CITY OF OPELIKA HISTORIC PRESERVATION COMMISSION

June 9, 2022

City of Opelika
Historic Preservation Commission
Staff Report

Agenda Item #: 1
Meeting Date: 06/09/22
Action Requested: COA: Replace windows, door, add balcony
Location of Property: 116 S. 8th St; Downtown Historic District
Petitioner: Hiro & Lyndsay Fakai

Proposed rendering

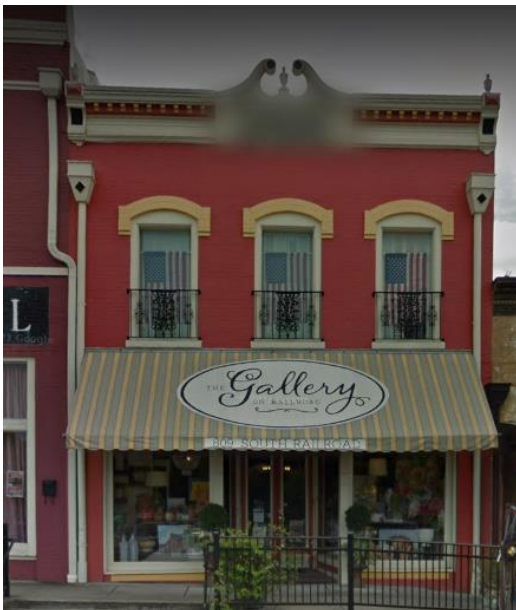
Wainscoting & flat panel trim detail
w/ dental molding & crown under
built-out soffit.

Install (2) new sconces (switch inside
doorway) fixtures.

Expose transom windows

Install new exterior door unit.

Install Juliette style balcony.

Accentuate architecture detail with
paint color.

Add fiber cement or similar trim
detail.

- 1 Staff recommends approval of removing existing plywood siding, touching up brick (may require repointing), and painting.
- 2 Staff recommends approval of replacing existing glass with clear transparent glass, tinted glass is not recommended. Staff recommends approval of replacing upper windows with wood, composite, or aluminum clad windows with same grid pattern of 2/2. Staff recommends approval of replacing two front entry doors with wood and glass doors of like kind or refinishing current doors.

- 3 Staff recommends approval of installing new wood residential doors on first and second floor. All doors to be submitted to Staff for approval prior to installation.

- 4 Staff recommends approval of fiber cement sheathing at windows. However, Staff recommends consideration of other alternative materials only under the following circumstances: a) the unavailability of historic materials b) the unavailability of skilled craftsmen c) inherent flaws in the original material, and 4) code-required changes. See Preservation Brief #16 provided.

- 5 Staff recommends approval of wood shadow box detailing around main entry and upper floor. New light fixtures to be submitted to Staff for approval prior to installation.

- 6 Staff recommends approval of fiber cement trim detail around upper-level windows.
- 7 Staff recommends approval of Juliet balcony contingent on city council approval and signed right of way agreement.

- 8 Painting of existing painted exterior does not require approval.
- 9 Staff recommends approval of flat metal canopy awning.

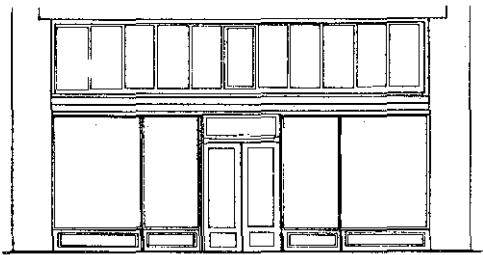
1. Retroactive request to replace rotted front columns with brick.

1. Staff recommends retroactive approval of brick columns on this non-contributing structure.
